**COUNTY OF VENTURA  
PUBLIC WORKS AGENCY**

**Addendum No. 1**

Subject: **Project Name: Hueneme Road at Arnold Road Drainage Improvements**  
**Specification No. RD16-02**  
**Project No. 50494**  
**Bids to be opened: October 6, 2015 at 2:00 p.m. (NO CHANGE)**

PROPOSED CULVERT PROFILE

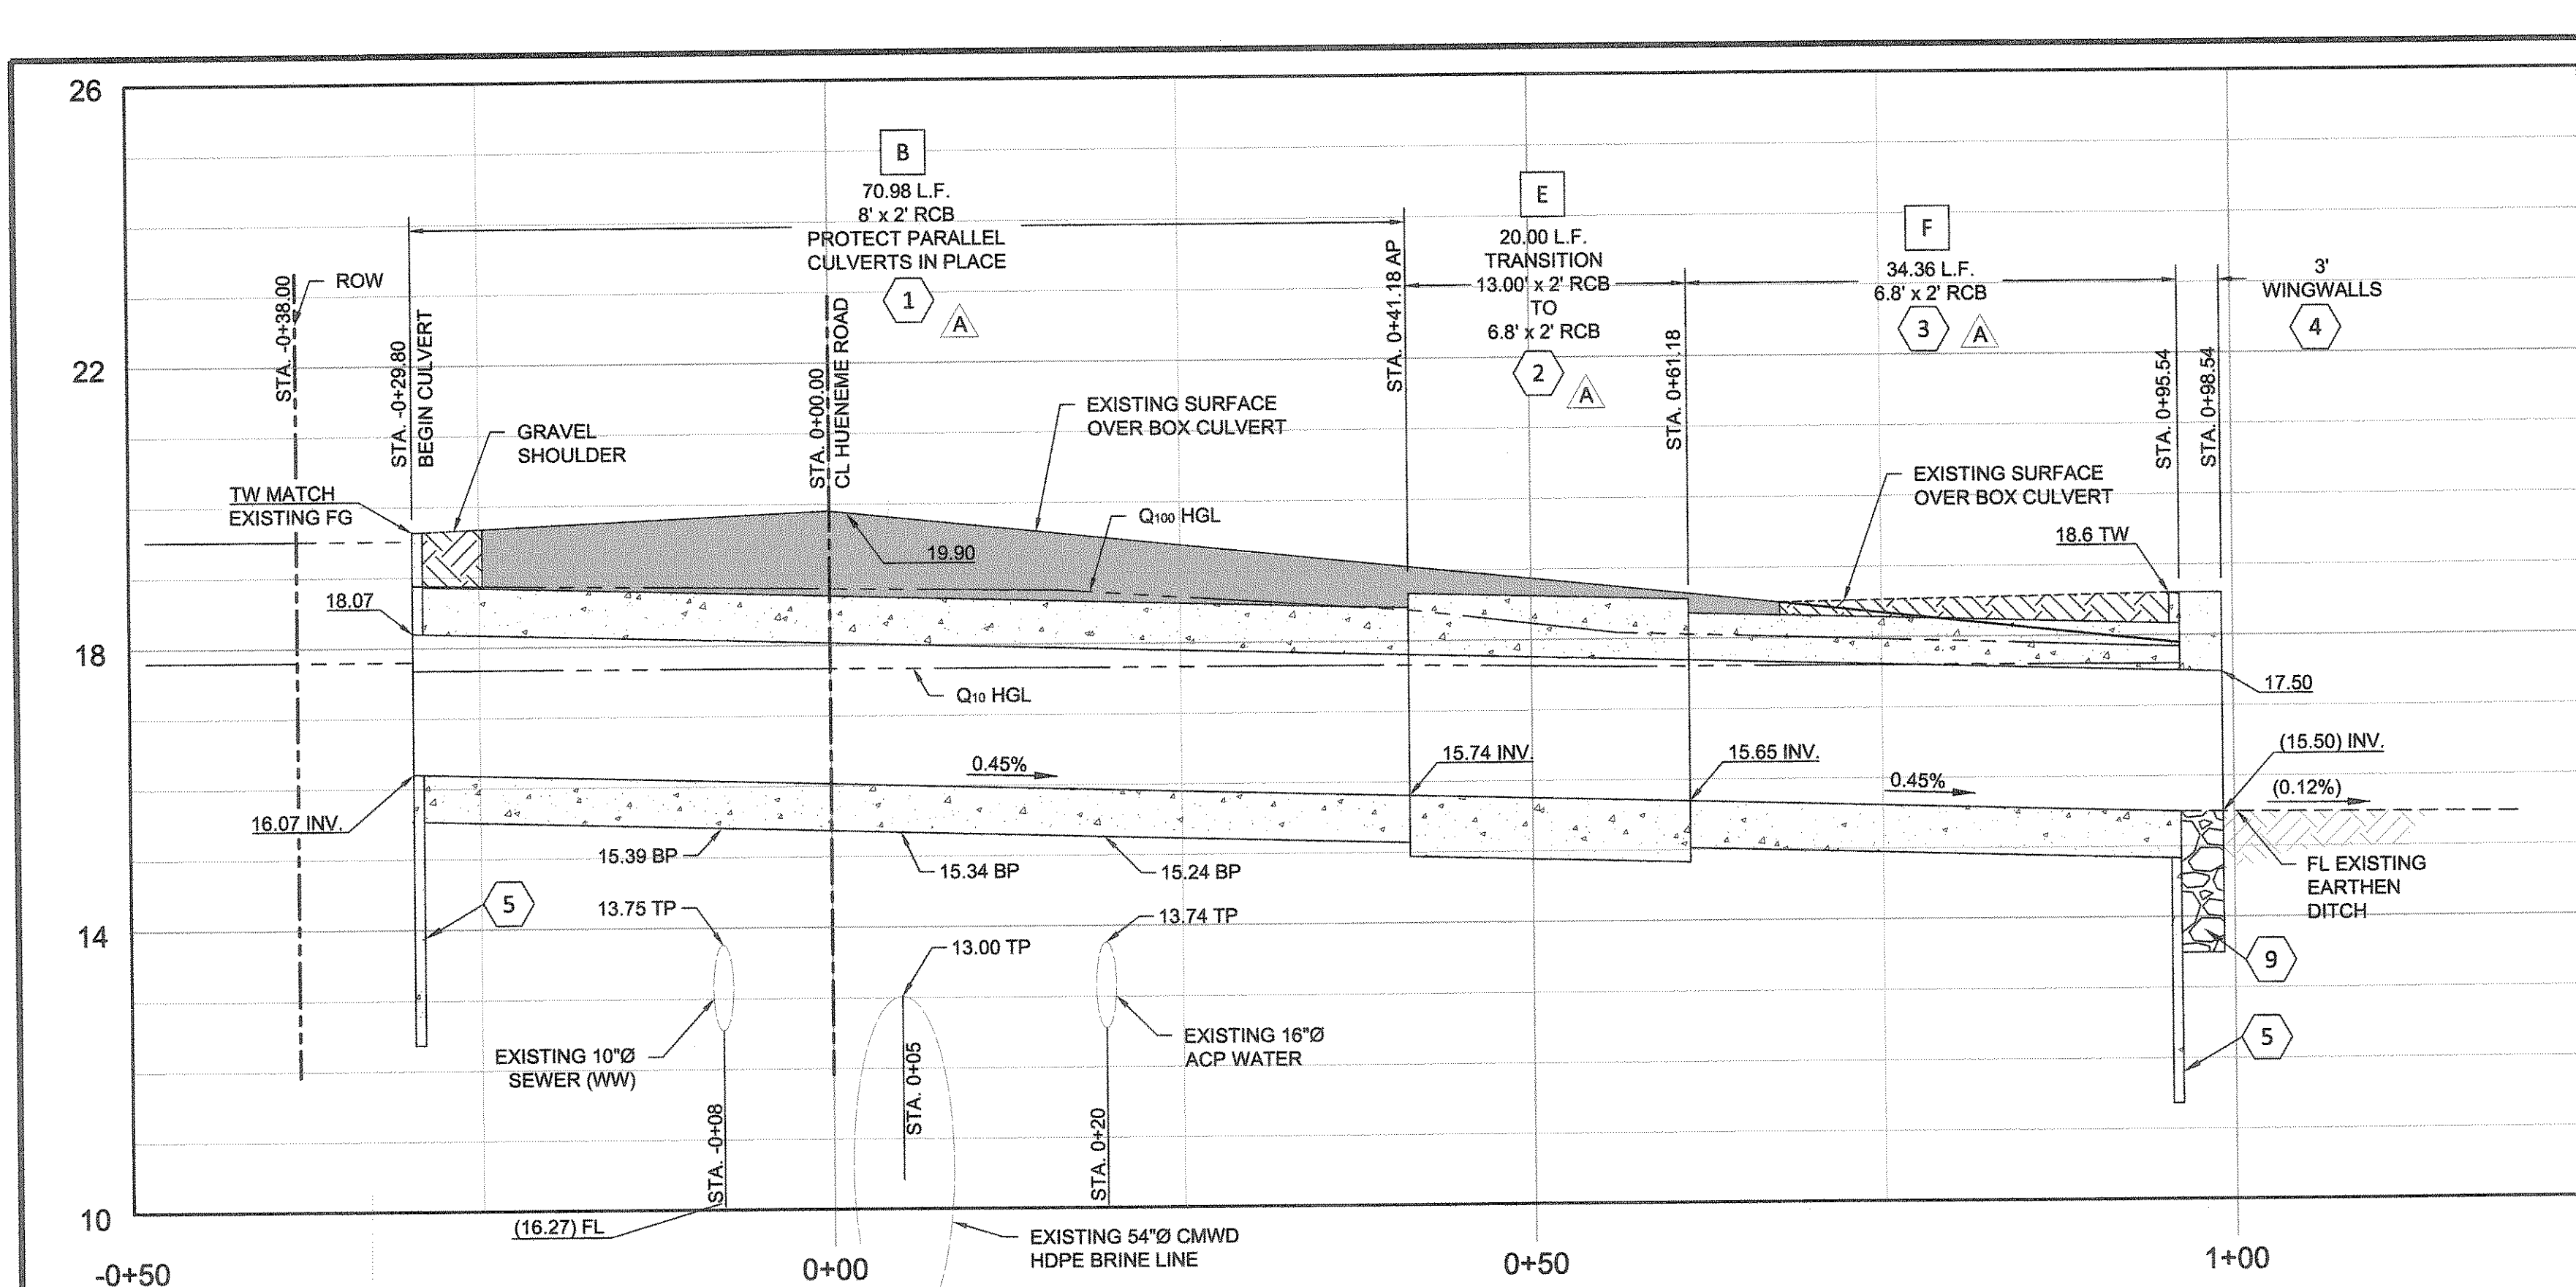
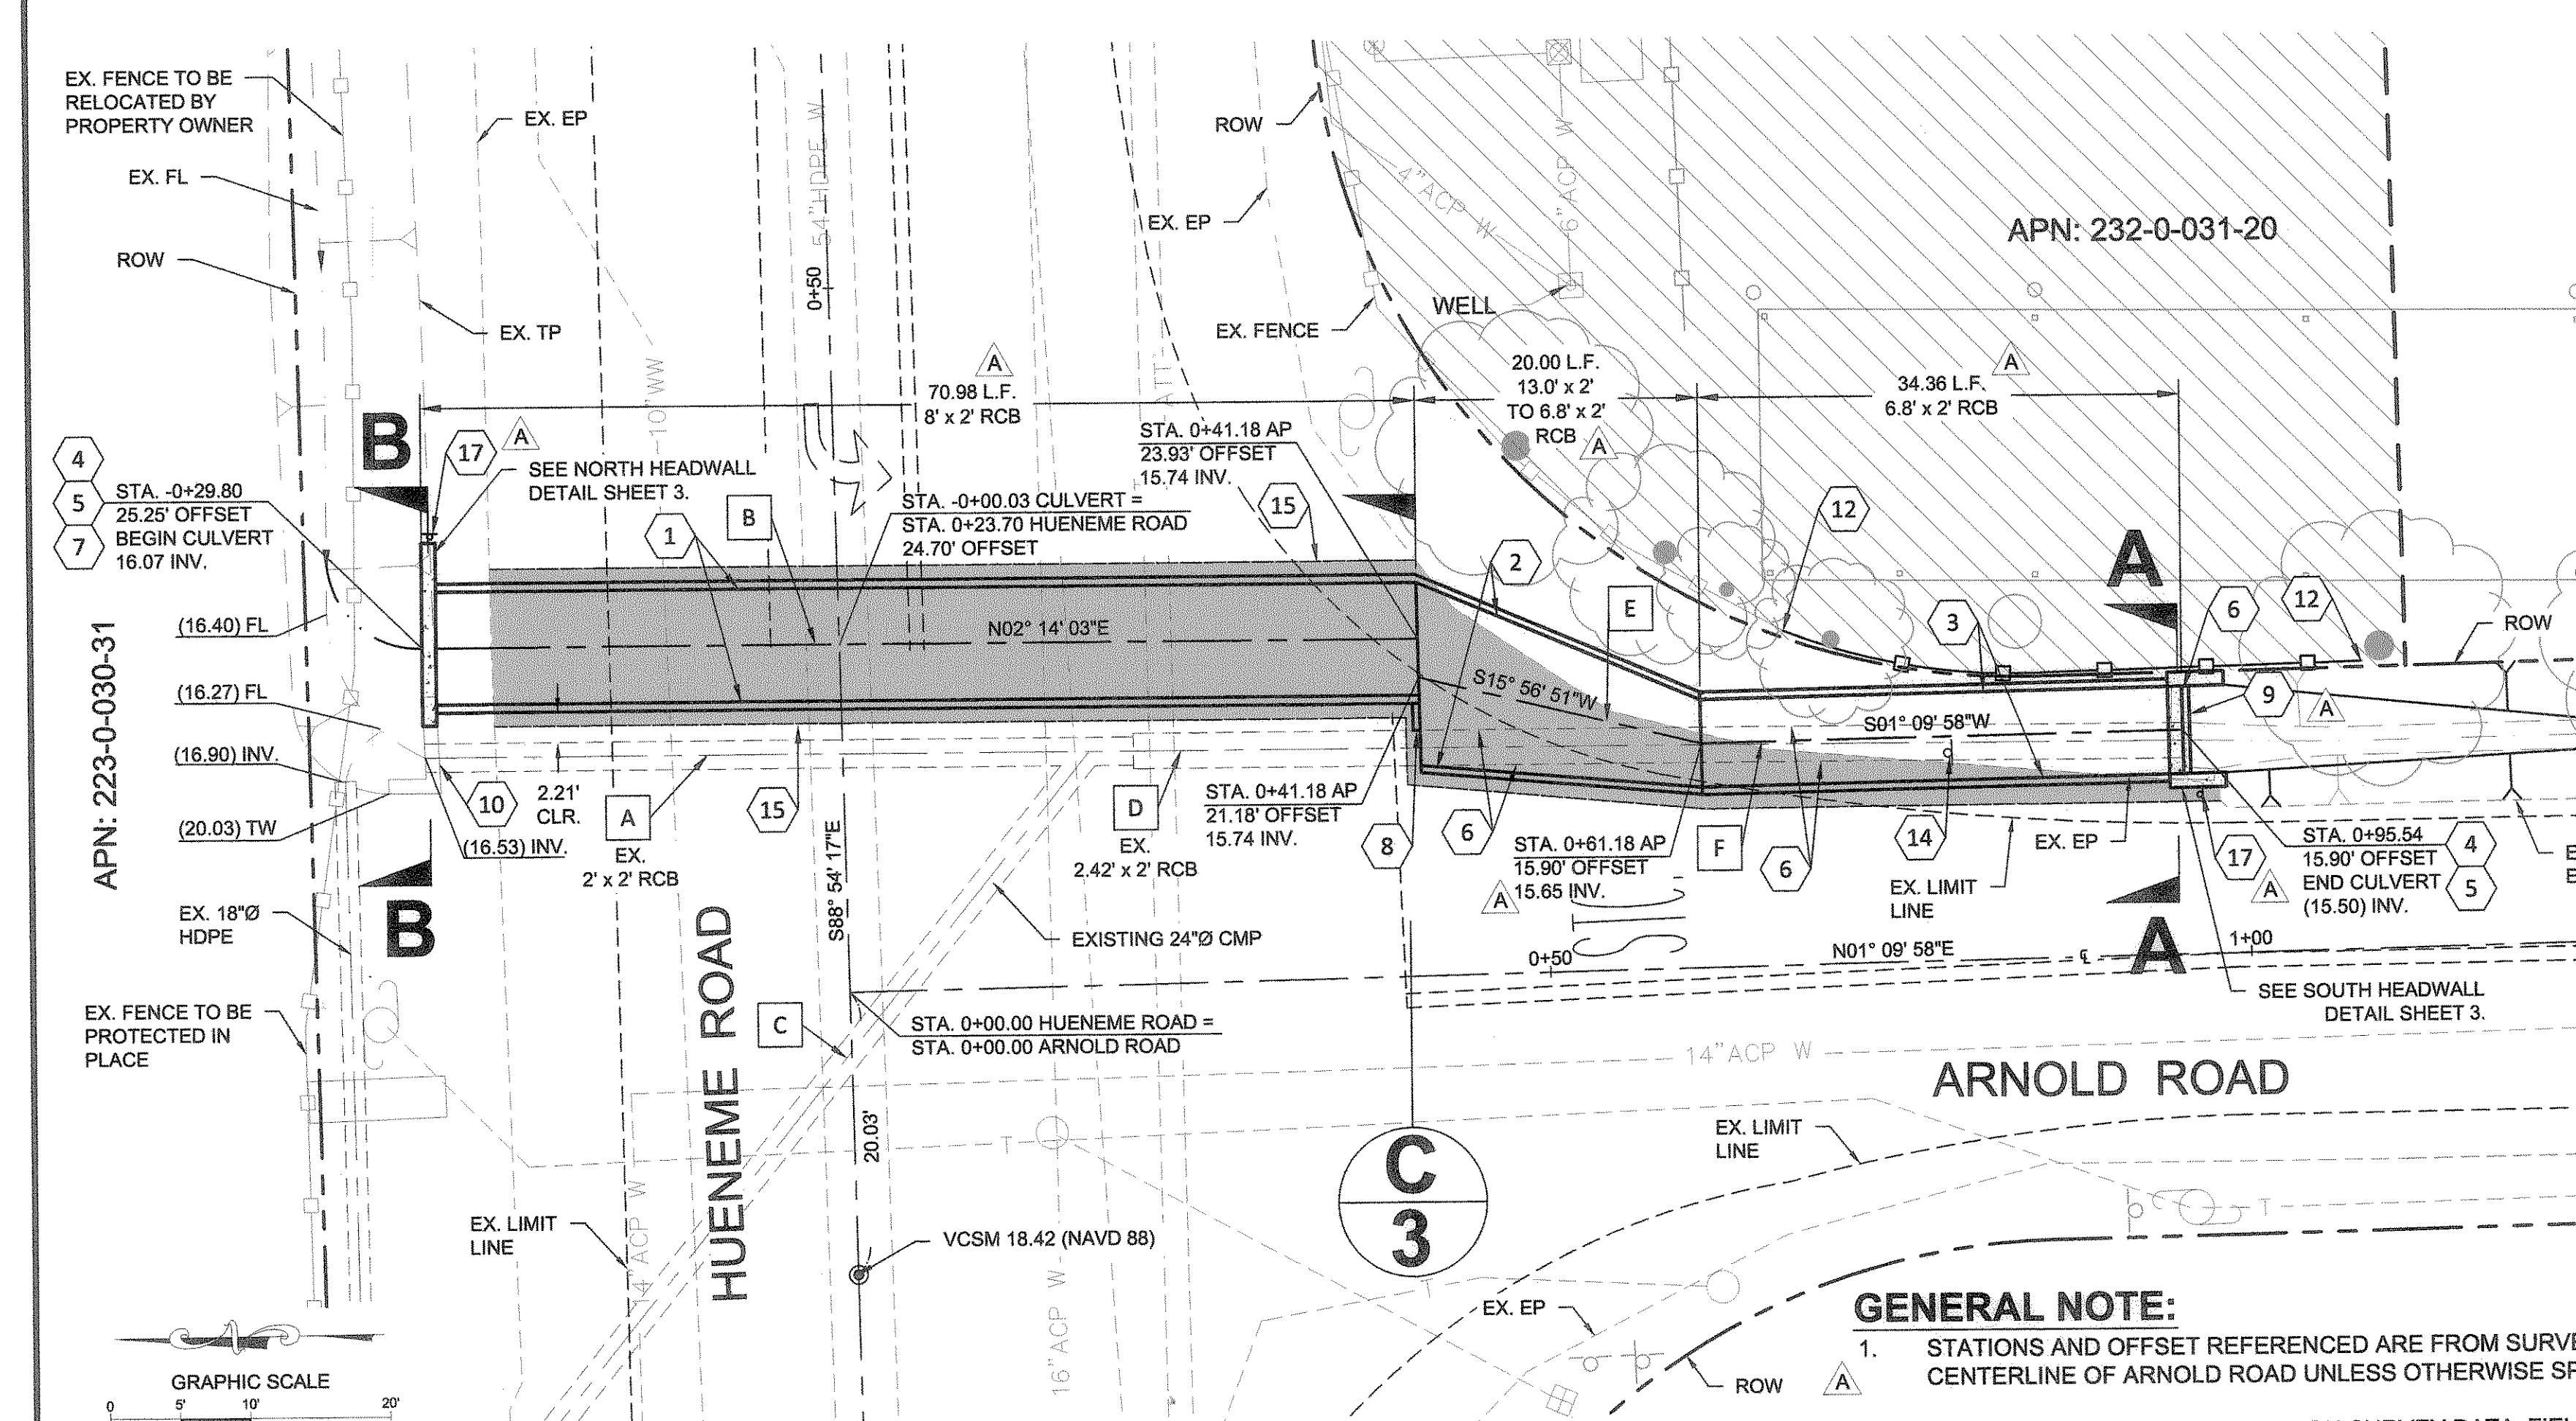
1. Bid Proposal shall be replaced with the attached Bid Proposal.
2. Remove and Replace from the Special Provisions sections 1000, 1006, 1007, 1011, 1012, and 1018 with the attached revised sections.
3. Remove entirely from the Special Provisions sections 1008, 1013, and 1014.
4. Remove and Replace Plan Sheets 1, 2, 3, and 8 with the Attached Plan Sheets.

D				BENCHMARK VENTURA COUNTY BENCH MARK - FOUND VCSM NEAR THE INTERSECTION OF HUENEME ROAD AND ARNOLD ROAD.	PREPARED BY:		 DEPUTY DIRECTOR, DESIGN DIVISION 9/28/15  DIRECTOR OF TRANSPORTATION 9/28/15  DIRECTOR OF PUBLIC WORKS	<b>COUNTY OF VENTURA PUBLIC WORKS AGENCY TRANSPORTATION DEPARTMENT</b>	SPEC NO. <u>RD16-02</u>	<b>HUENEME ROAD AT ARNOLD ROAD DRAINAGE IMPROVEMENTS TITLE SHEET</b>	SHEET <u>1</u> OF <u>8</u>
C				NAVD 88 ELEV. = 18.42	PROJ. NO. <u>50494</u>				DRAWING NO. <u>115087</u>		
B											
A	HORIZONTAL AND VERTICAL DATUM BASED ON "VENTURA COUNTY FIELD BOOK 2015-040". MODIFIED CULVERT DESIGN, MODIFIED DELINEATOR LOCATIONS	9/25/15									
△	REVISION	DESCRIPTION	APP.	DATE

DETAIL SHEET

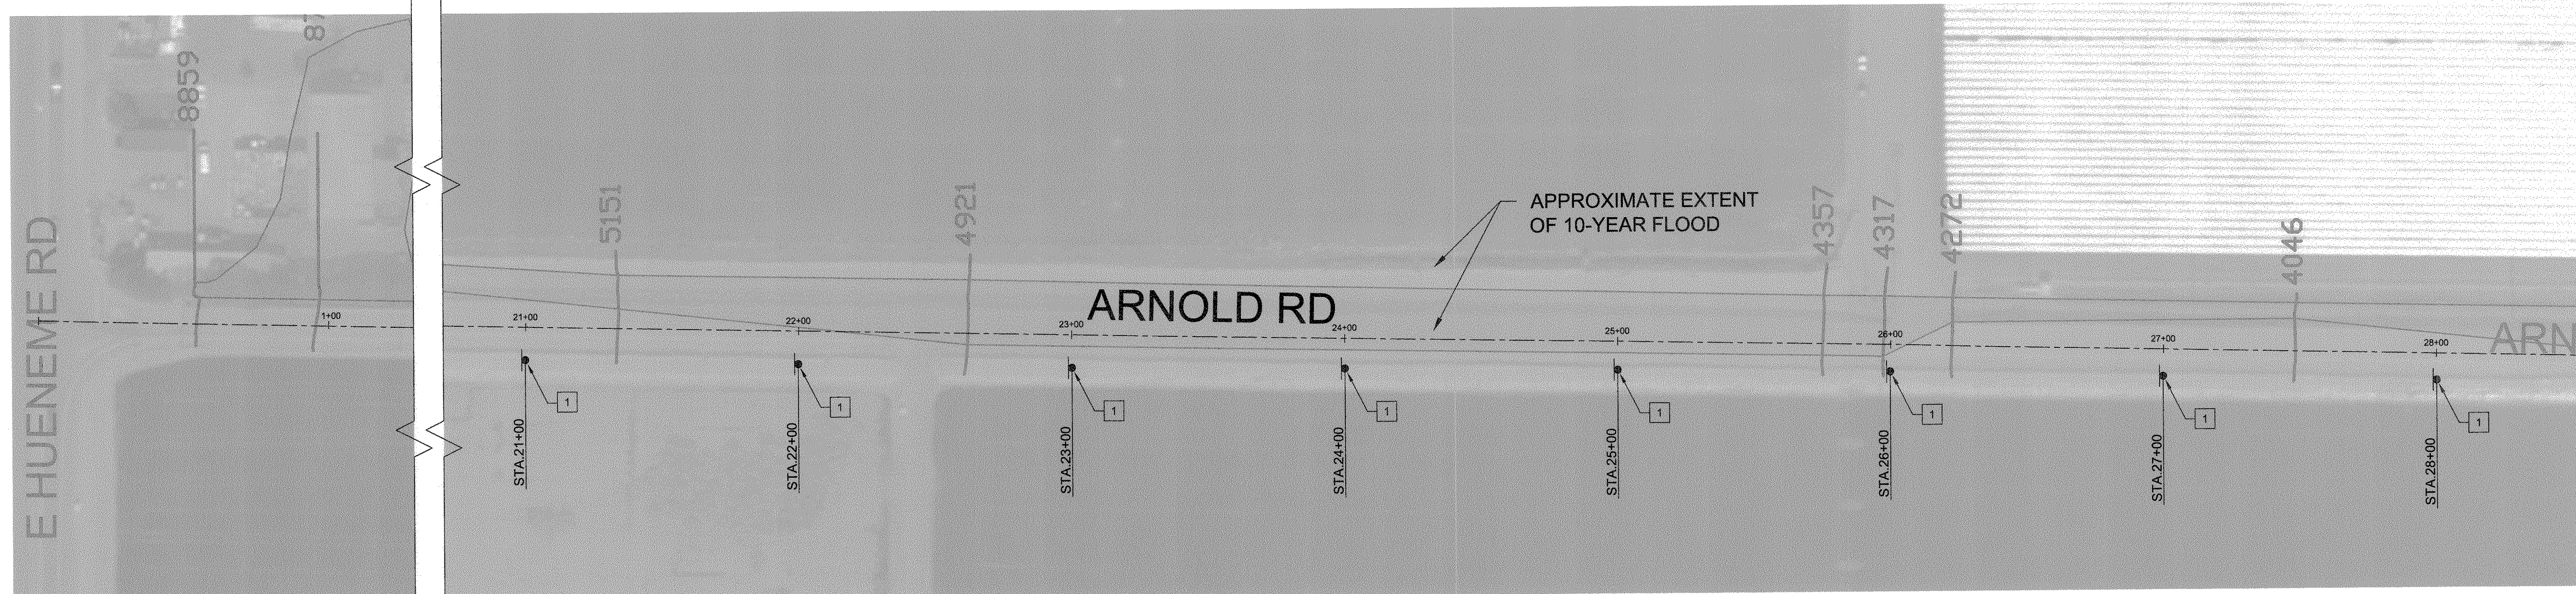
D	BENCHMARK VENTURA COUNTY BENCH MARK - FOUND VCSM NEAR THE INTERSECTION OF HUENEME ROAD AND ARNOLD ROAD.	PREPARED BY: <b>NextGen</b> ENGINEERING	B. O'BRIEN DESIGN BY: F. PONCE DRAWN BY: B. O'BRIEN CHECKED BY:	COUNTY OF VENTURA PUBLIC WORKS AGENCY TRANSPORTATION DEPARTMENT	SPEC NO. RD16-02	HUENEME ROAD AT ARNOLD ROAD DRAINAGE IMPROVEMENTS PLAN AND PROFILE	SHEET 2 OF 8
C	NAVD 88 ELEV. = 18.42				PROJ. NO. 50494		DRAWING NO. 115088
B	HORIZONTAL AND VERTICAL DATUM BASED ON 'VENTURA COUNTY FIELD BOOK 2015-040'. MODIFIED CULVERT DESIGN, MODIFIED DELINEATOR LOCATIONS	9/25/15					
A	REVISION	DESCRIPTION	APP.	DATE

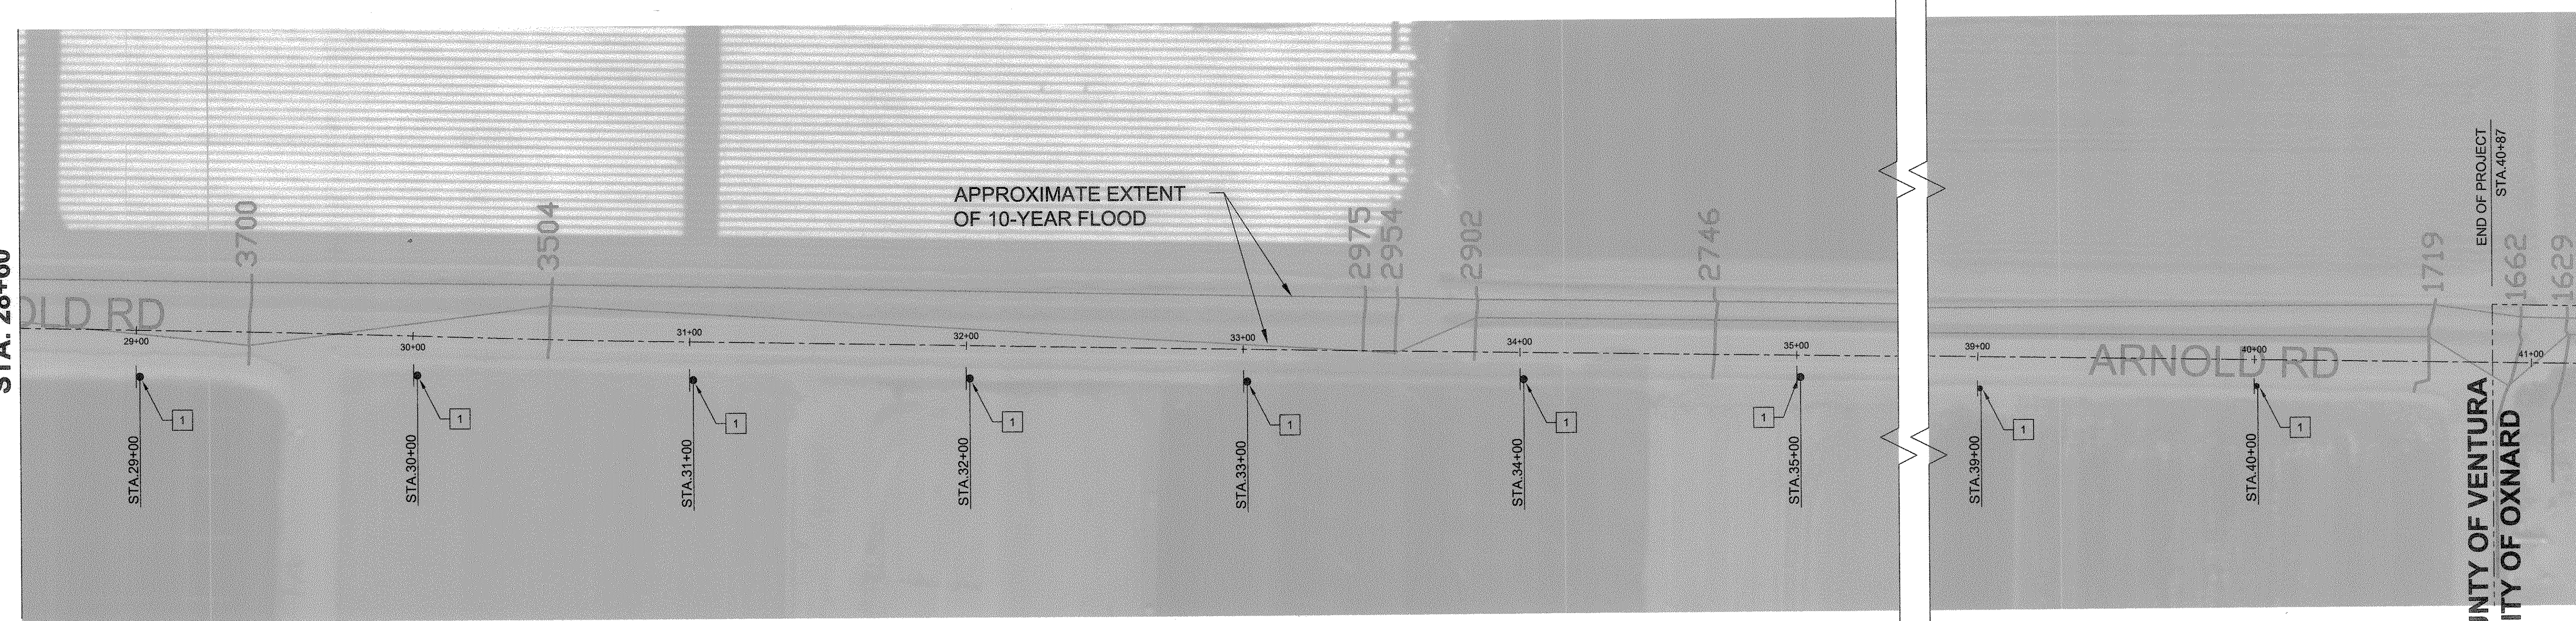
<div> <div>D</div> <div>C</div> <div>B</div> <div>A</div> <div>Δ</div> </div> <div> <div>HORIZONTAL AND VERTICAL DATUM BASED ON "VENTURA COUNTY FIELD BOOK 2015-040". MODIFIED CULVERT DESIGN. MODIFIED DELINEATOR LOCATIONS</div> <div>REVISION DESCRIPTION APP. DATE</div> </div>	<div> <div>BENCHMARK</div> <div>VENTURA COUNTY BENCH MARK - FOUND VCSM NEAR THE INTERSECTION OF HUENEME ROAD AND ARNOLD ROAD.</div> <div>NAVD 88 ELEV. = 18.42</div> <div>HORIZONTAL AND VERTICAL DATUM IS BASED ON "VENTURA COUNTY FIELD BOOK 2015-040".</div> </div> <div> <div>9/25/15</div> <div>APP. DATE</div> </div>	<div> <div>PREPARED BY:</div> <div>NextGen ENGINEERING</div> </div>	<div> <div>B. O'BRIEN</div> <div>DESIGN BY:</div> <div>F. PONCE</div> <div>DRAWN BY:</div> <div>B. O'BRIEN</div> <div>CHECKED BY:</div> </div>	<div> <div>COUNTY OF VENTURA</div> <div>PUBLIC WORKS AGENCY</div> <div>TRANSPORTATION DEPARTMENT</div> </div>	<div> <div>SPEC NO.</div> <div>RD16-02</div> <div>PROJ. NO.</div> <div>50494</div> </div>	<div> <div>HUENEME ROAD AT ARNOLD ROAD</div> <div>DRAINAGE IMPROVEMENTS</div> <div>SAFETY DELINEATOR LOCATIONS</div> </div>	<div> <div>SHEET 8</div> <div>OF 8</div> <div>DRAWING NO. 115094</div> </div>
